APPLICATION NO.	FILING DATE	FIRST NAMED INVENTOR	ATTORNEY DOCKET NO.	CONFIRMATION NO.
10/537,122	12/06/2005	Johannes Georg Schaede	1204.1112101	8386

Office Action Summary	Application No. 10/537,122	Applicant(s) SCHAEDE, JOHANNES GEORG	
	Examiner Michael P. Stafira	Art Unit 2886

- 1) ☐ Responsive to communication(s) filed on ____.
- 2a) ☒ This action is **FINAL**. 2b) ☐ This action is non-final.
- 3) ☐ Since this application is in condition for allowance except for formal matters, prosecution as to the merits is closed in accordance with the practice under *Ex parte Quayle*, 1935 C.D. 11, 453 O.G. 213.

FIG. 10

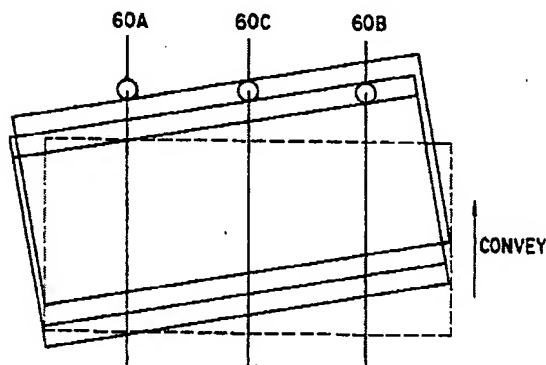
Sakamori ('257) discloses providing a first trigger (Fig. 10, Ref. 60a) at a selected first location along the direction of displacement of the substrate for detecting the passage of an edge of the substrate at said first location (Col. 5, lines 51-59); providing a second trigger (Fig. 10, Ref. 60B) at a selected second location after said first trigger along the direction of displacement of the substrate for detecting the passage of an edge of the substrate at said second location (Col. 5, lines 51-59); providing at least a first checkpoint detector (Fig. 10, Ref. 60c) at a selected third location between said first (Fig. 10, Ref. 60a) and second triggers (Fig. 10, Ref. 60b) along the direction of displacement of the substrate (See Fig. 10), said at least first checkpoint detector

(Fig. 10, Ref. 60c) being adapted to detect the passage of said edge of the substrate at a selected place along said edge which is different than the place at which said first (Fig. 10, Ref. 60a) and second triggers (Fig. 10, Ref. 60b) are adapted to detect the passage of said edge (Col. 10, lines 6-62); detecting the passage of said edge of the substrate at said selected locations by means of said first trigger (Fig. 10, Ref. 60a), said at least first checkpoint detector (Fig. 10, Ref. 60c) and said second trigger (Fig. 10, Ref. 60b); controlling whether the passage of said edge of the substrate was detected by said at least first checkpoint detector (Fig. 10, Ref. 60c) after detection by said first trigger (Fig. 10, Ref. 60a) and before detection by said second trigger (Fig. 10, Ref. 60b); and generating an integrity check failed message in case the passage of said edge of the substrate was not detected by said at least first checkpoint detector (Fig. 10, Ref. 60c) after detection by said first trigger (Fig. 10, Ref. 60a) and before detection by said second trigger (Fig. 10, Ref. 60b)(Col. 11, lines 1-47).

Sakamori ('257) discloses the edge is the leading edge and/or the trailing edge of the substrate (See Fig. 10).

Sakamori ('257) discloses a first trigger (Fig. 10, Ref. 60a) arranged at a selected first location along the direction of displacement of the substrate for detecting the passage of an edge of the substrate at said first location (See Fig. 10); a second trigger (Fig. 10, Ref. 60b) arranged at a selected second location after said first trigger along the direction of displacement of the substrate for detecting the passage of an edge of the substrate at said second location (See Fig. 10) (Col. 10, lines 6-62); at least a first checkpoint detector (Fig. 10, Ref. 60c) arranged at a selected third location between said first (Fig. 10, Ref. 60a) and second triggers (Fig. 10, Ref. 60b) along the direction of displacement of the substrate (See Fig. 10), said at least first checkpoint detector (Fig. 10, Ref. 60c) being adapted to detect the passage of said edge of the substrate at a selected place along said edge which is different than the place at which said first (Fig. 10, Ref. 60a) and second triggers (Fig. 10, Ref. 60b) are adapted to detect the passage of said edge; and a computer element (Fig. 4, Ref. 100) adapted to control whether the passage of said edge of the substrate was detected by said at least first checkpoint detector (Fig. 10, Ref. 60c) after detection by said first trigger (Fig. 10, Ref. 60a) and before detection by said second trigger (Fig. 10, Ref. 60b)(Col. 11, lines 1-47).

Examiner takes the position that the claim limitations fail to disclose where the detectors are placed in relation to the substrate and nowhere does the limitations disclose they are spatially arranged. The claim limitations only discloses the detector is placed along the direction of

displacement of the substrate, which the reference of Sakamori ('257) clearly shows detectors 60a-60c displaced along the substrate as seen in Figure 10 of Sakamori ('257). The claims limitations do not indicate the substrate has to be parallel or perpendicular to the detectors and therefore the reference of Sakamori ('257) reads on applicant's claimed limitations.
